# Access Compliance Report

## Public Rights-of-Way

### (Curb Ramps)

Intersection ID: 29698	Main Street: SIMFIELD_CHURCH_RD	Cross Street: WOODCROFT_WY	Location: SW
ADA ID: CA250108F91F	Ramp Type: Perp	Initial Pass/Fail: Fail	Overall Compliance: No
Severity Score: 21.25			
Codes/Mitigation Info/Possible Solution		Field Measurements/Component Compliance

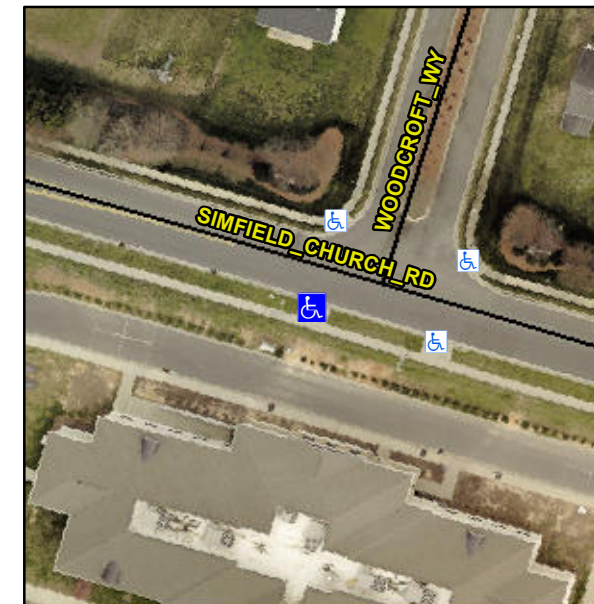
**Not Found, R304.5.1, R304.2.2**

Compliance	Description	Data	Compliance	Description	Data
N/A	Ramp Length (in)	96.0	No	Ramp Slope (%)	8.6
No	Ramp Width (in)	47.0	Yes	Ramp XSlope (%)	0.6
N/A	Flare Type LT	N/A	N/A	Flare Type RT	N/A
N/A	Flare Slope LT (%)	N/A	N/A	Flare Slope RT (%)	N/A
N/A	Flare Traversable LT?	N/A	N/A	Flare Traversable RT?	N/A
N/A	Landing Length (in)	N/A	N/A	DWS Provided?	N/A
N/A	Landing Width (in)	N/A	N/A	DWS Contrast?	N/A
N/A	Landing Slope (%)	N/A	N/A	DWS Length (in)	N/A
N/A	Landing X Slope (%)	N/A	N/A	DWS Full Width?	N/A
N/A	Landing Curb? (Y/N)	N/A	N/A	DWS Offset (in)	N/A
N/A	Shared Landing?	N/A			
N/A	Gutter Ponding?	N/A	N/A	Gutter Slope (%)	N/A
N/A	Gutter Lip Ht (in)	N/A	N/A	Gutter X Slope (%)	N/A
N/A	Painted X Walk1?	No	N/A	Painted X Walk2?	N/A
	X Walk 1 Direction	To N		X Walk 2 Direction	N/A
N/A	X Walk 1 Width (in)	N/A	N/A	X Walk 2 Width (in)	N/A
	X Walk 1 Slope (%)	1.7		X Walk 2 Slope (%)	N/A
	X Walk 1 X Slope (%)	1.0		X Walk 2 X Slope (%)	N/A

**Remove & Replace Entire Ramp.**
